Bulletin #FMS003

2026 RH Lidar Holster Mount Update

Date: 8/28/2026

Old mount - holster behind mount point.

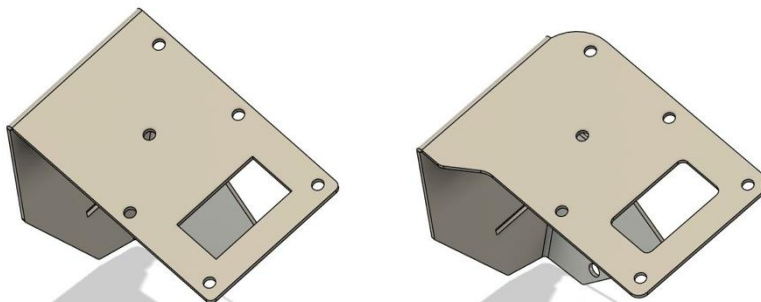
Old mounts look like the ones below.

New mount - holster ahead of mounting point

Complaint: Riders reported that the early Lidar gun holster mounts for 2026 R 1300 RT-P models may alter the path of hot air from the radiator exhaust, causing rider discomfort.

Solution: After extensive testing, a redesigned holster mount was developed for the R 1300 RT-P which moves the holster forward to eliminate disruption of radiator heat exhaust.

Field Solution: Replace early version Lidar gun holster mounts with the new mount. This will eliminate the air deflection, though heat is still exhausted from the radiator.

New RH Lidar Holster Mount

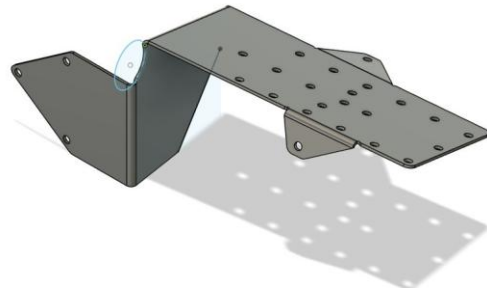
Note: Early Zebra printer mounting brackets attached to the Lidar mounting bracket. A new bracket will be needed that will work with all combinations or stand alone. That new bracket shown above is in production now with availability in early September. The new Zebra mount will be available for purchase once in stock.
